Well Name: POKER LAKE UNIT 28-21 BS MON	Well Location: T25S / R31E / SEC 28 / NENE /	County or Parish/State:
Well Number: 158H	Type of Well: CONVENTIONAL GAS WELL	Allottee or Tribe Name:
Lease Number: NMLC062140A	Unit or CA Name: POKER LAKE	Unit or CA Number: NMNM071016X
US Well Number: 3001548957	Well Status: Approved Application for Permit to Drill	Operator: XTO PERMIAN OPERATING LLC

Notice of Intent

Procedure Description: **Surface Location Move, Name Change, Spacing, Casing/Cement, Drilling Variance Changes XTO Permian Operating, LLC requests permission to make the following changes to the original APD: Change name fr/Poker Lake Unit 28-21 BS 158H to Poker Lake Unit 28-21 BS Mon 158H XTO Permian Operating, LLC. requests to make this a monitoring well to collect formation pressure responses in establishing greater understanding of parent/child relationships between wellbores. This data is beneficial for Poker Lake Unit to assist in an accelerated understanding of the number of wells and spacing configurations required to optimize Federal oil and gas mineral development throughout the unit. The monitoring well will either be converted to a producer or be plugged within 5-years

13-3/8" x 9-5/8" x 5-1/2" 10M RSH-2 Wellhead
Assembly, With T-EBS-F Tubing Head

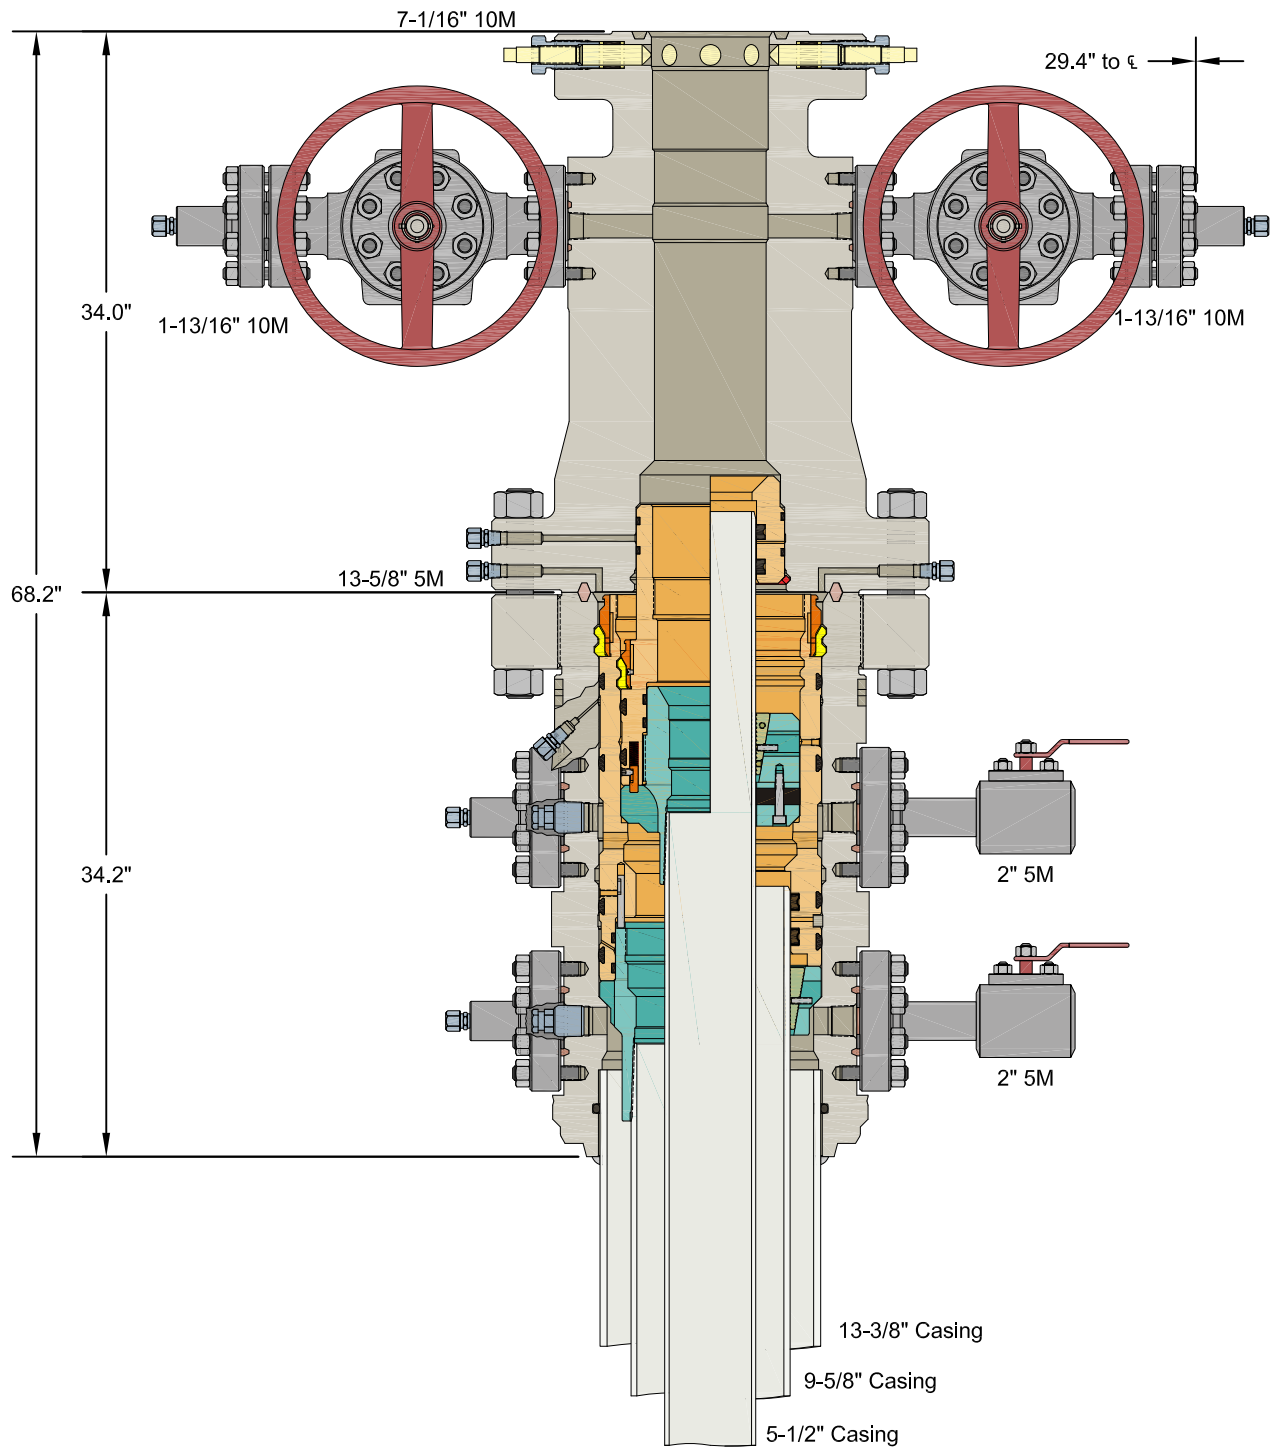
Permanent Wellhead – Multibowl System

A. Starting Head: 13-5/8" 10M top flange x 13-3/8" SOW bottom

B. Tubing Head: 13-5/8" 10M bottom flange x 7-1/16" 15M top flange

- Wellhead will be installed by manufacturer's representatives.
- Manufacturer will monitor welding process to ensure appropriate temperature of seal.

- Operator will test the 7-5/8" casing per BLM Onshore Order 2
- Wellhead Manufacturer representative will not be present for BOP test plug installation

1. Operator has proposed a multi-bowl wellhead assembly. This assembly will only be tested when installed on the surface casing. Minimum working pressure of the blowout preventer (BOP) and related equipment (BOPE) required for drilling below the surface casing shoe shall be **5000 (5M)** psi.

- a. Wellhead shall be installed by manufacturer's representatives, submit documentation with subsequent sundry.
 - b. If the welding is performed by a third party, the manufacturer's representative shall monitor the temperature to verify that it does not exceed the maximum temperature of the seal.

- c. Manufacturer representative shall install the test plug for the initial BOP test.
 - d. If the cement does not circulate and one inch operations would have been possible with a standard wellhead, the well head shall be cut off, cementing operations performed and another wellhead installed.
